UNITED STATES PATENT AND TRADEMARK OFFICE

APPLICATION NO.	FILING DATE	FIRST NAMED INVENTOR	ATTORNEY DOCKET NO.	CONFIRMATION NO.
09/701,254	11/27/2000	Norio Nagatsuka	SON-1684/KOI	7973

Office Action Summary	Application No.	Applicant(s)	
	09/701,254	NAGATSUKA ET AL.	
	Examiner	Art Unit	
	McDieunel Marc	3661

DETAILED ACTION

Figure 1. Kismet with toys. Kismet has an active stereo vision system with color CCD cameras mounted inside the eyeballs. There are also a variety of facial features which give the robot its expressive capabilities. (Caretaker, 1998").

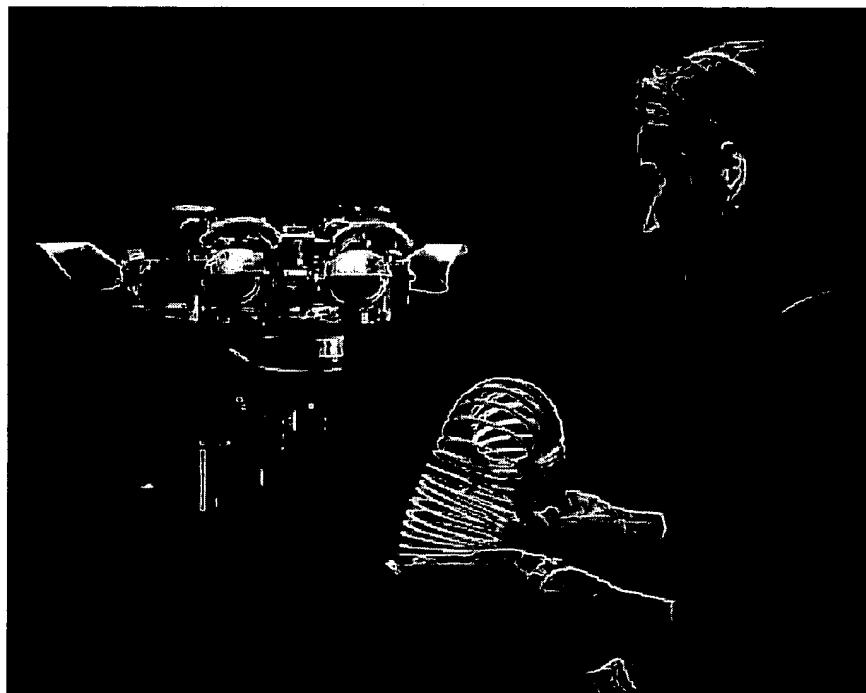
As per claims 1, 65 and 84, Breazeal et al. teaches a system including “Infant-like Social Interactions between a Robot and a Human Caretaker” (Fig. 1) comprising an emotion module (see Figs. 9-11, particularly *Motivation System*) affect one another to output an emotion (see Figs. 9-11, particularly *Motor System*), please note that motivation system being readable as emotion module and Motor system being taken as outputted emotion; and action means for acting on the basis of the emotion of the emotion outputted by the emotion module (see entire Figs. 9-11).

With respect to claim 84, detection means for detecting a stimulus applied from outside (see Fig. 1);

Figure 2. Static extremes of Kismet's facial expressions. During operation, the 11 degrees-of-freedom for the ears, eyebrows, mouth, and eyelids vary continuously with the current emotional state of the robot.

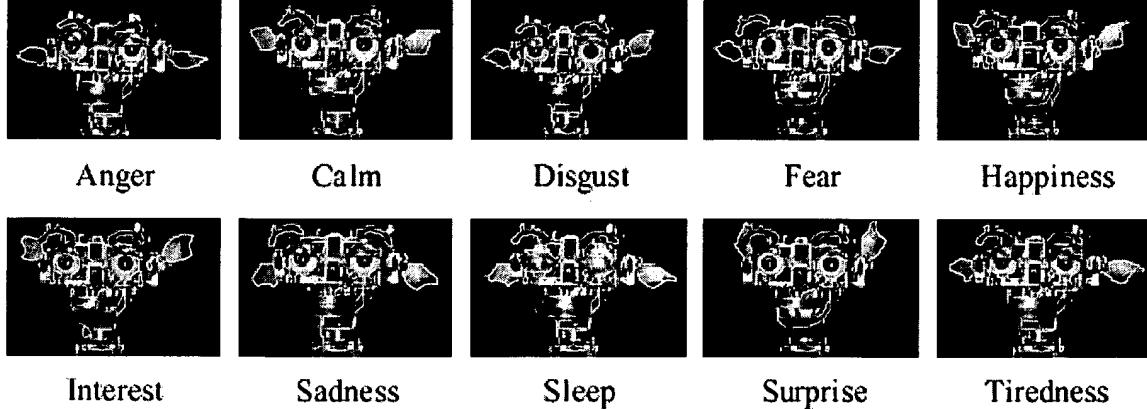
With respect to claim 65, an emotion module in which a plurality of emotion units representing emotions output individual emotions (see Figs. 2 and 9);

an instinct module in which a plurality of instinct units representing instincts output individual instincts (see Figs. 1 and 2);
